ADDENDUM NO. 30 - Contract Drawing C.1

**CONTRACT 876-HP
GEOMEMBRANE CAPPING AND
GAS COLLECTION SYSTEM
PELHAM BAY LANDFILL REMEDIATION
BOROUGH OF THE BRONX
NEW YORK**

Bid Form - Contract No. 876-HP - Revised 5/25/94

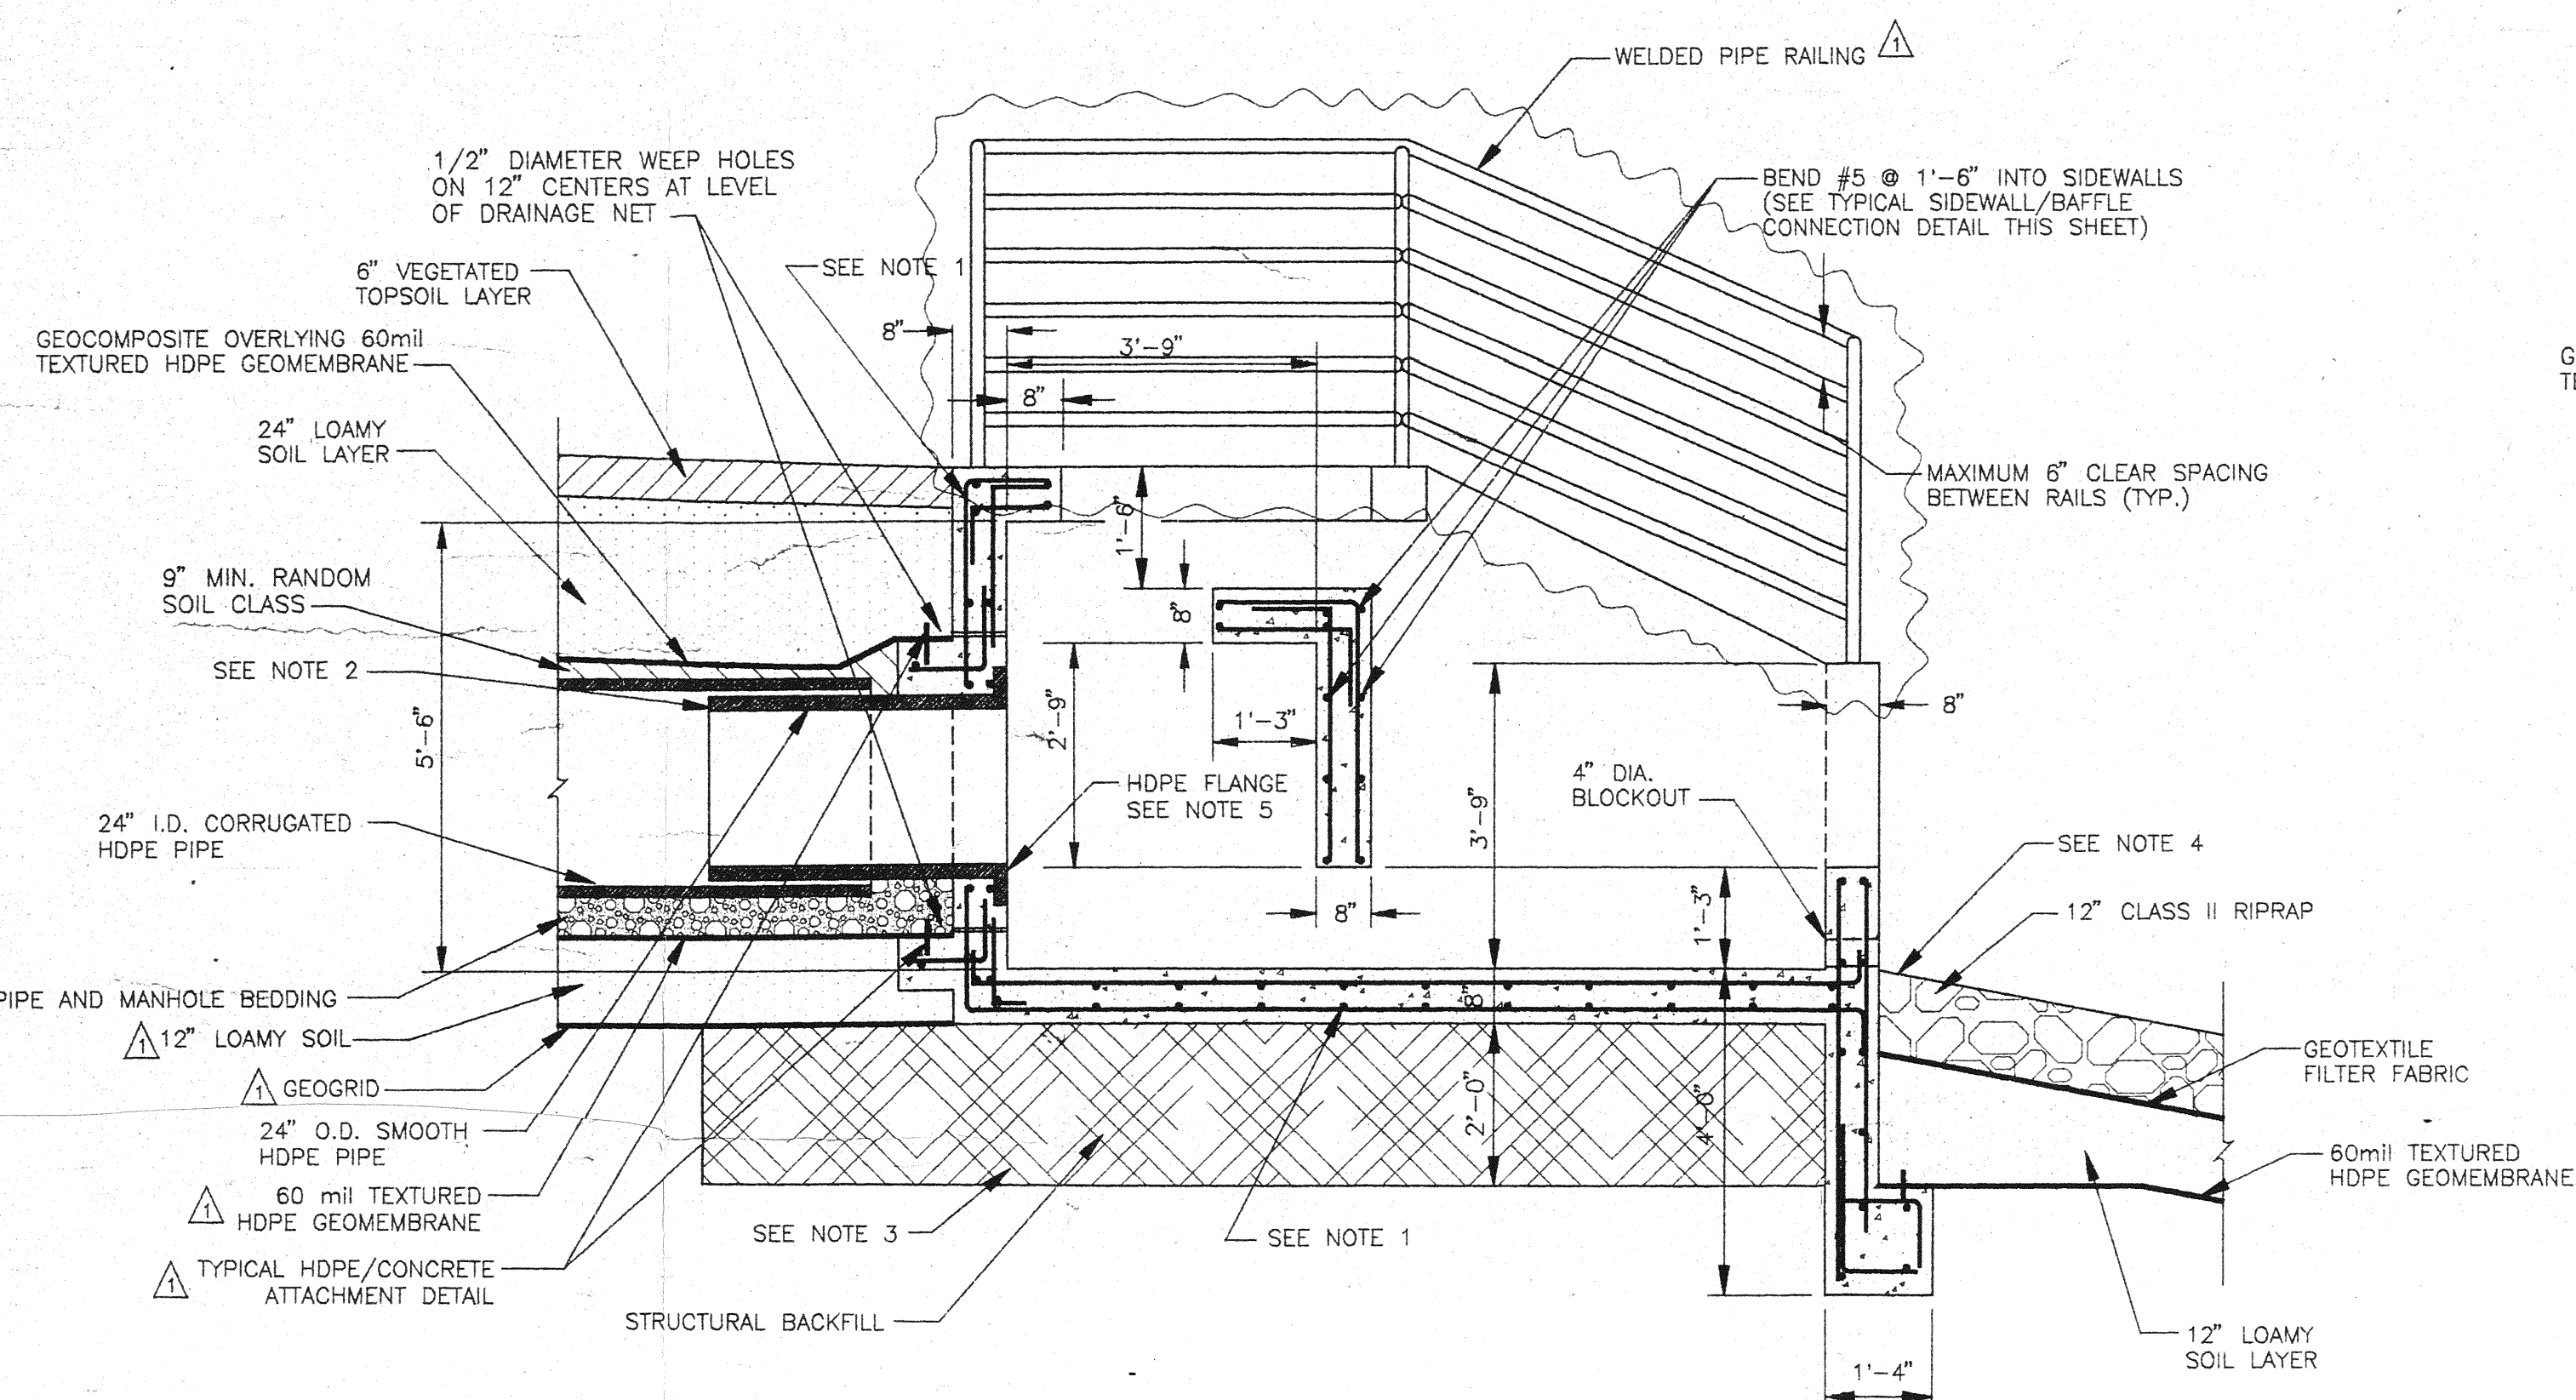
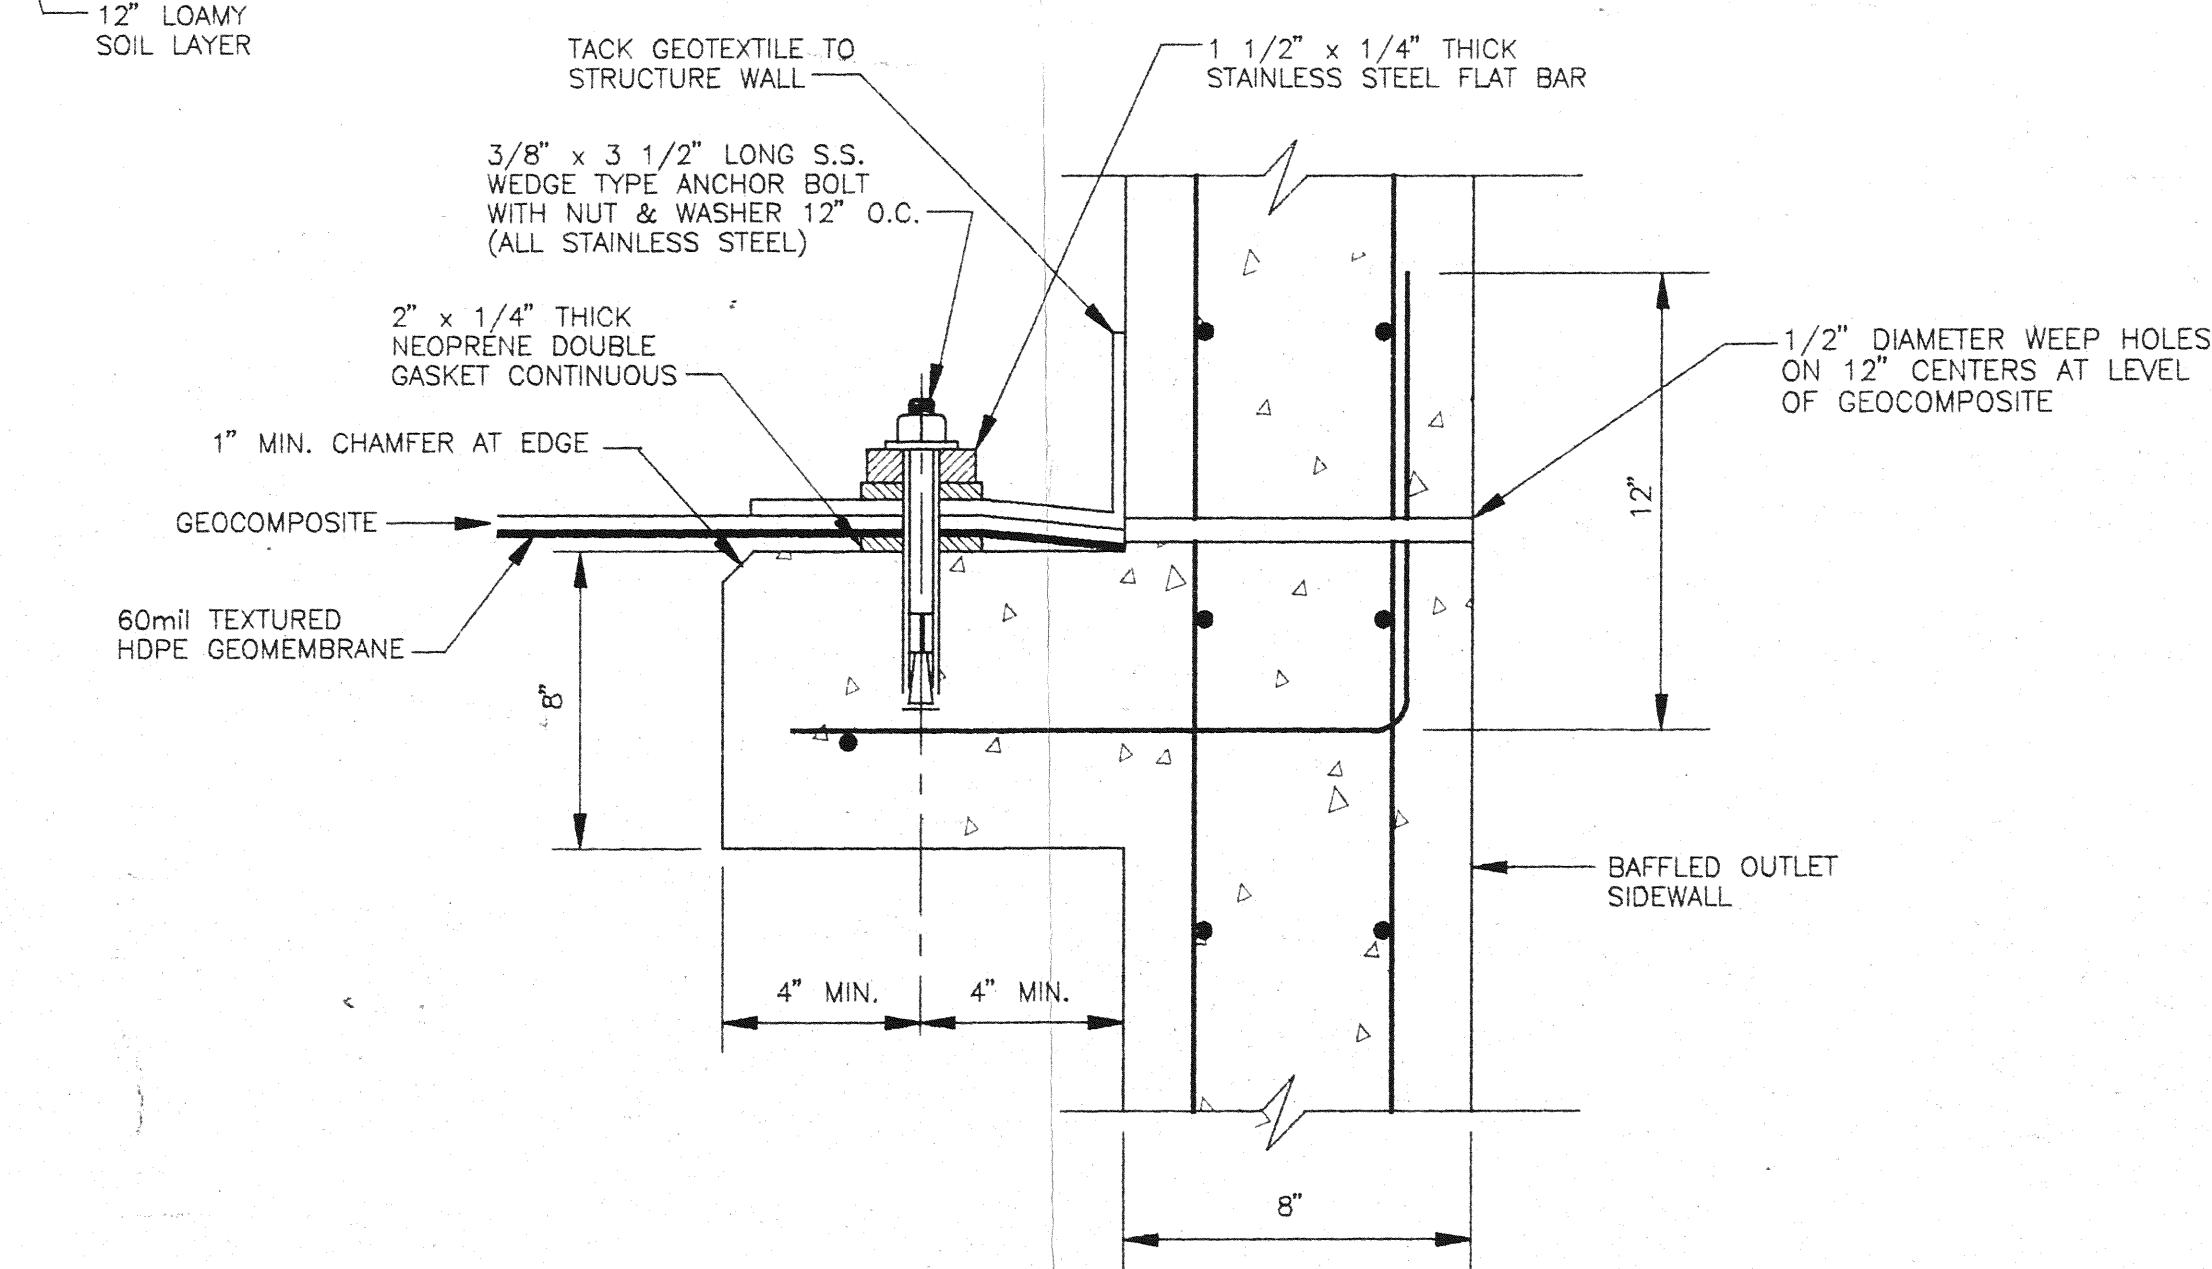
1. Replace Contract Drawing C.11 with revised version (Drawing C.11R1), attached at the end of this package. Revisions made to this Drawing are described below:
 - A. New details (mainly spacing) for the Welded Pipe Railing.
 - B. Revisions to "BAFFLED OUTLET - SECTION A".

Refer to sheet 12/28, BAFFLED OUTLET SECTION SHOWING TYPICAL EARTHWORK: Note 3 is referenced in this section. Reference is made to "STRUCTURAL BACKFILL" on the right side of the section. There is no item for structural backfill. Please clarify and/or define what item(s) the payment limit lines represent.

Refer to sheet 12/28, BAFFLED OUTLET: On the plan, upper left this sheet, there is a note with regard to the handrail to see note 4. Note 4 refers to rip rap. Further, nowhere can we find the size of the handrail members. Please clarify.

Structural Backfill is incidental to the "**Outlet Structure**" work defined in item No. 120 of the revised Bid Form presented in Addendum No. 64 as is with other structure items. Note 3 on Drawing C.11 refers to the bid items, and structural excavation and structural backfill are incidental to that item.

Refer to Addendum No. 34 for revised drawing C.11R1. For the size of the handrails, see answer to question 15.
